## MEMORANDUM

**SUBJECT:** Zoning Commission Case No. 13-18: **Setdown Report** for a Consolidated Planned Unit Development and Zoning Map Amendments for Square 5925 at 4129-4131 Wheeler Rd. SE

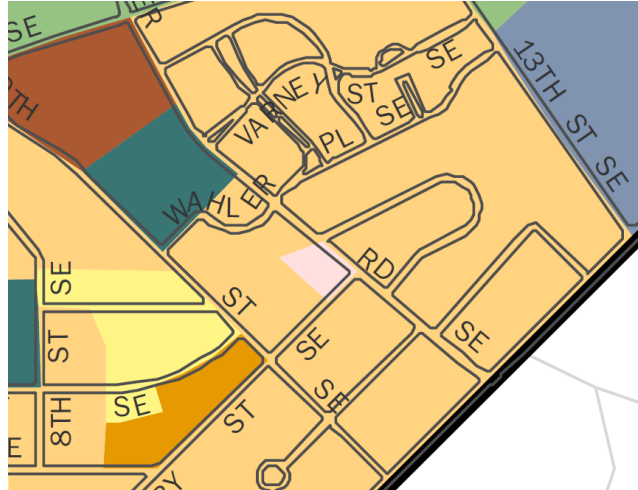
The Applicant requests relief for a portion of the penthouse structure which houses the elevator located on the eastern side of the building as it is not in conformity with the 1:1 ratio from bounding walls. Page 11 of the submitted plan shows the penthouse roof plan but there is no single plan that shows measurements that do not meet the required setback. The Applicant should provide drawings more clearly illustrating the areas of non-conformity.
